SHAKE RAG MITIGATION SITE

SUBJECT: Shake Rag Mitigation Site - NCIRT Comments during 30-day Mitigation Plan Review

RE: Shake Rag Mitigation Site
Madison County, NC
USACE AID#: SAW-2017-01570, NCDMS #: 100018
FINAL Mitigation Plan – IRT Comment Response

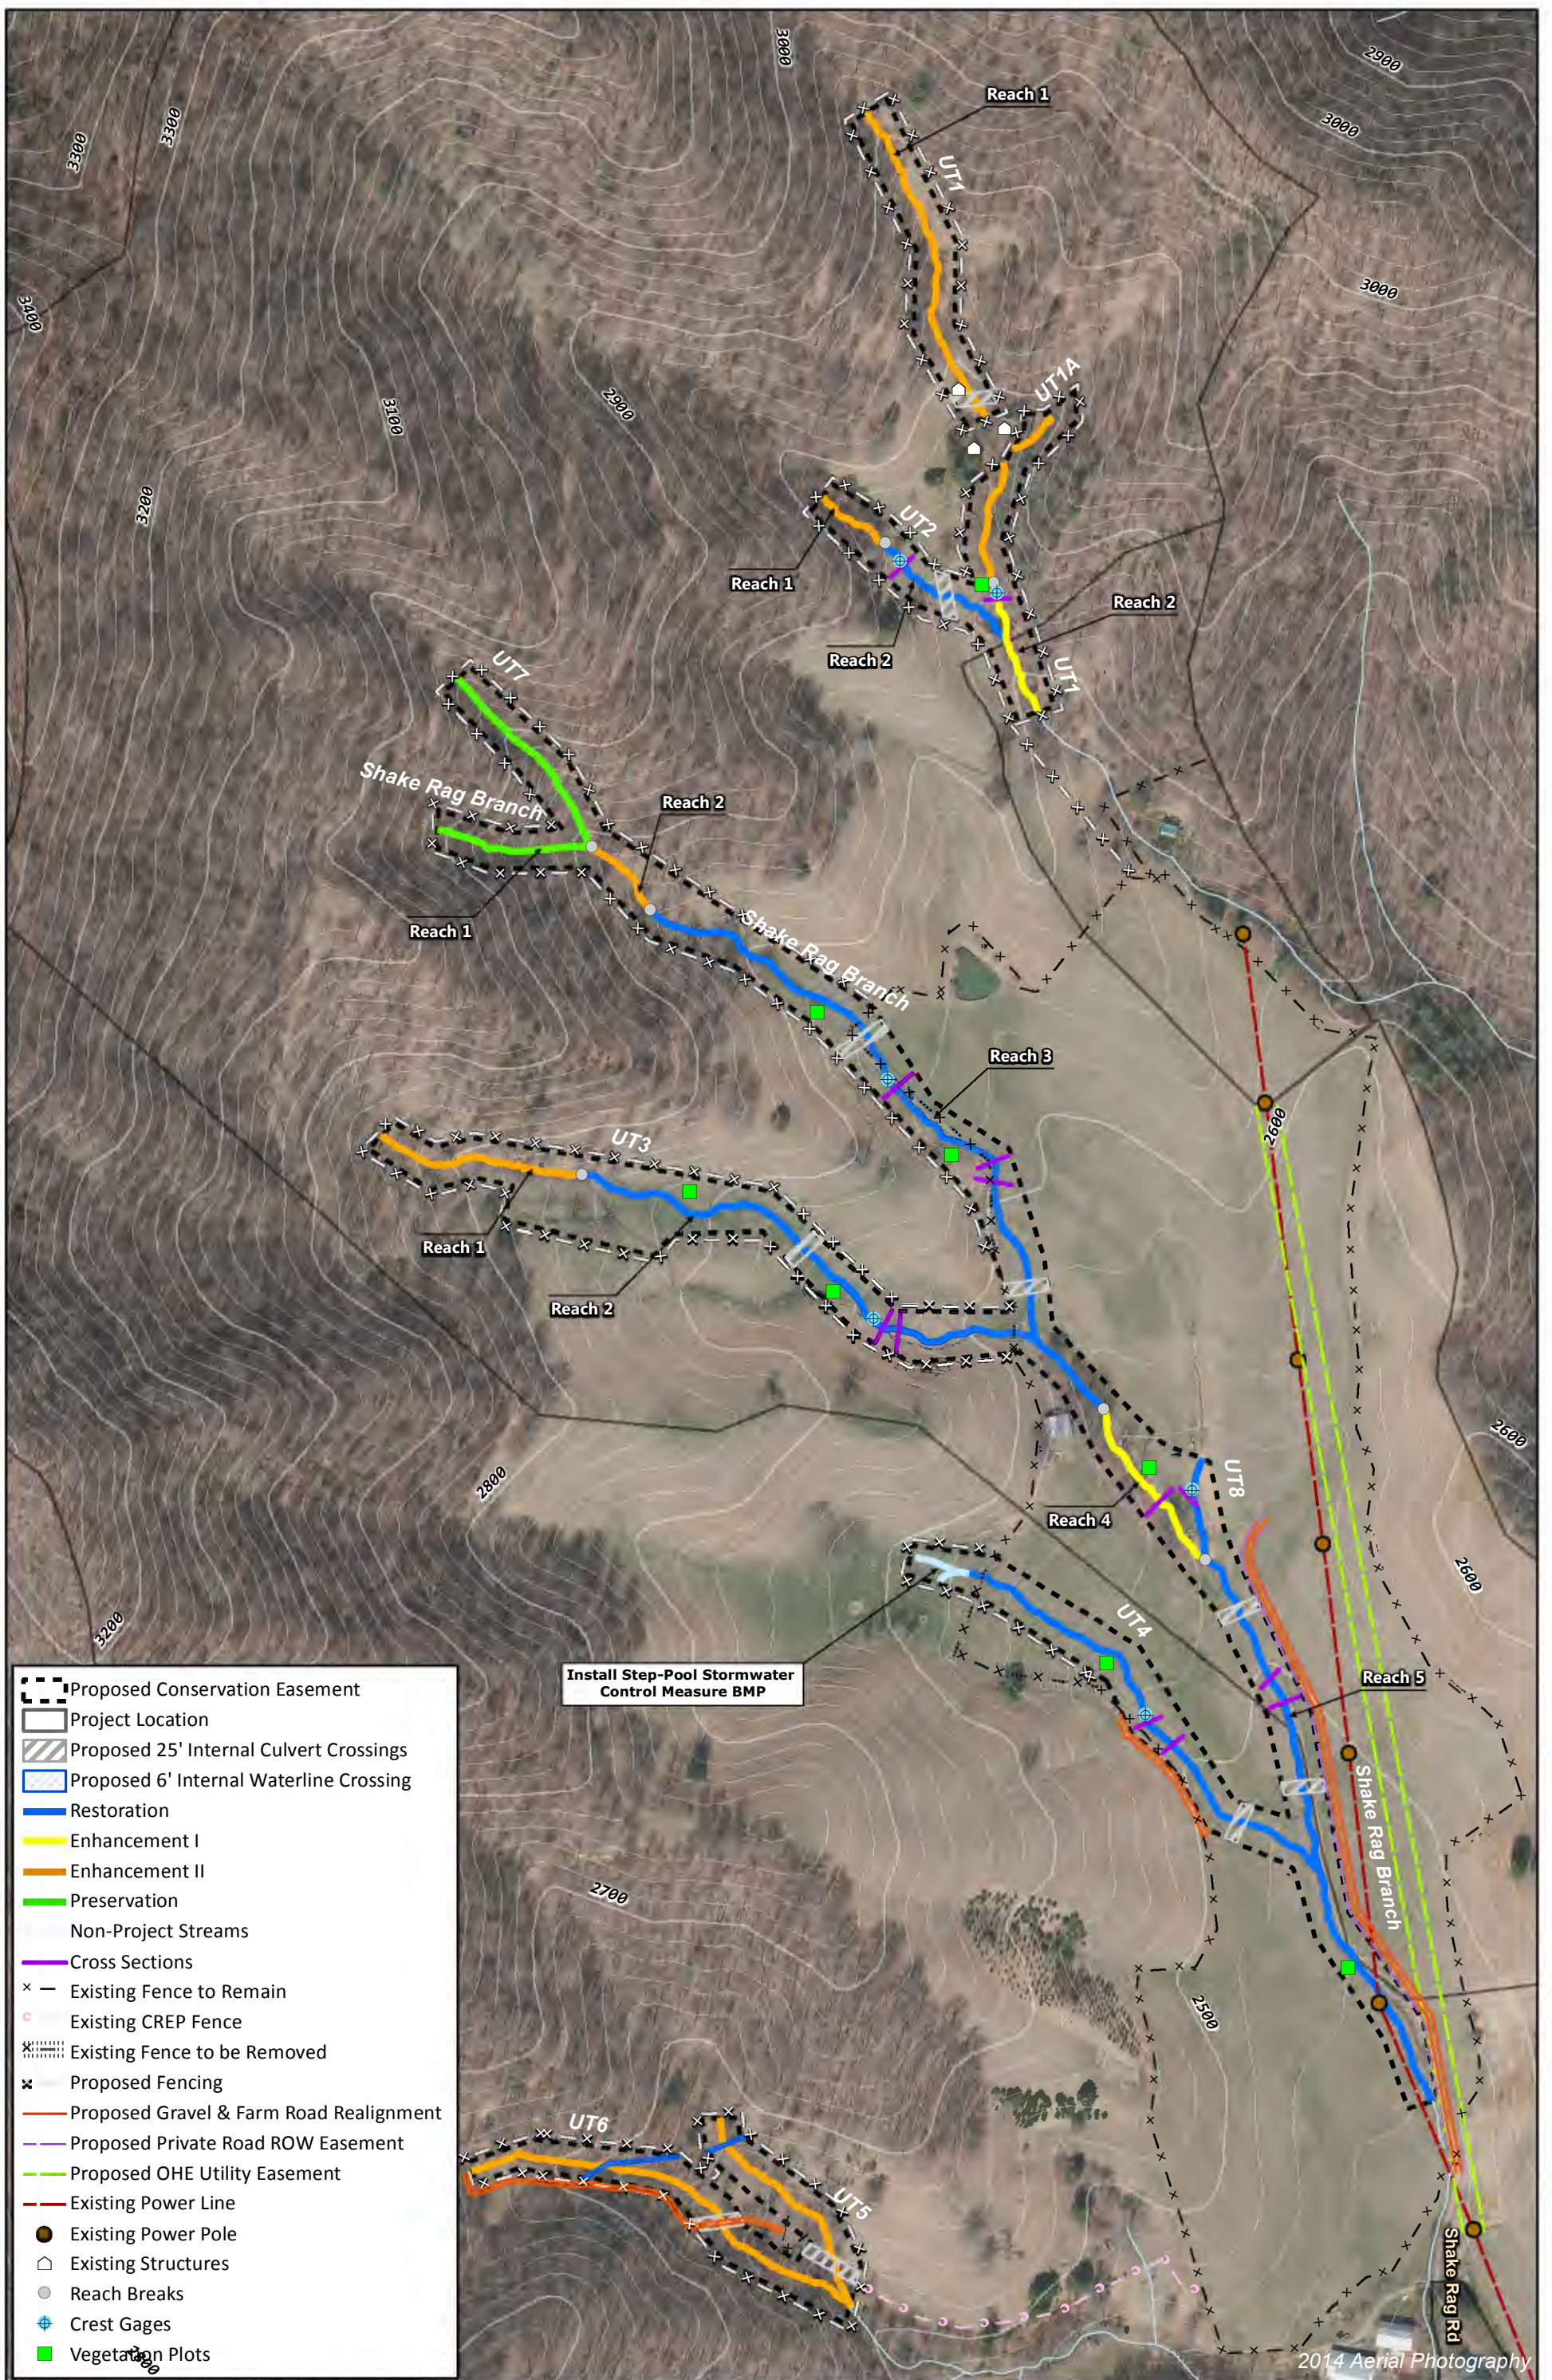
- a. Section 8.2: monitoring should occur for seven years, and the vigor standards should be 7' high at year 5 and 10' high at year 7.
 - b. It would be helpful to see the location of the photo reference stations on the monitoring map, figure 9.

- b. (response to comment “b”) - Photo reference stations will be provided on annual monitoring report maps but are typically not included as part of the mitigation plan monitoring map.
